## City of Coral Gables Planning and Zoning Staff Report

Applicant: Jorge Navarro, Esq./Devon Vickers, Esq.  
Application: Variance – VARI-24-04-0014  
Property: 1501 and 1505 Sunset Drive  
Legal Description: Lots 21, 22, and 23, less the West 9 feet, Block 205, Coral Gables Riviera Section Part 14  
Present Owners: One Sunset, LLC  
Present Use: Apartment Buildings/Office Use  
Zoning District: Mixed-Use 1 (MX1) District  
Public Hearing: Board of Adjustment  
**Date & Time: Monday, August 5, 2024; 9:00 a.m.**  
Location: First Floor Conference Room, Development Services  
427 Biltmore Way, Coral Gables, Florida 33134

### 1. APPLICATION REQUEST

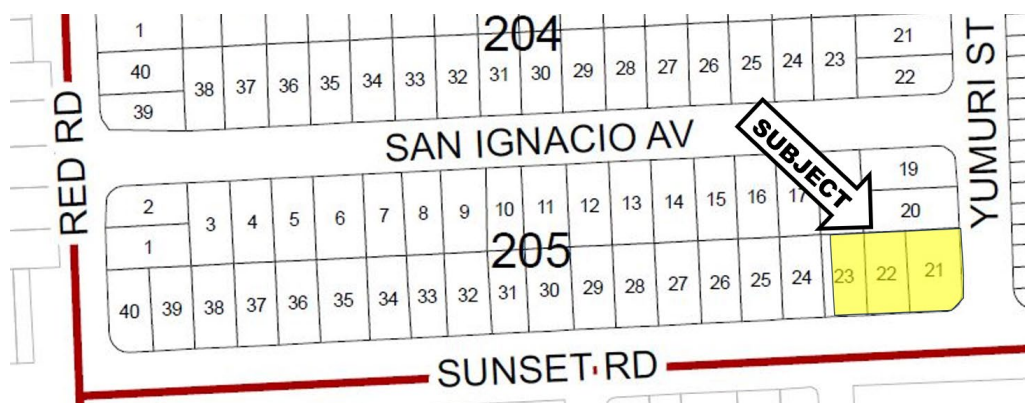
*On the rear, a 10-foot setback is provided on the ground level which continues straight up, no upper story setback is provided on this side which abuts an existing parking garage. This is also where access to the site is being provided, through Yumuri Street. In addition, this block is platted in different orientation, while the subject site is platted north-south, the abutting north side (the garage) is platted east-west as shown below.*

*Staff does find special condition and circumstances that exist which are peculiar to the land that warrants granting setback reductions as requested due to the corner lot location and the aim to maintain building symmetry of the front façade; the platting orientation, and the as built condition of the abutting garage.*
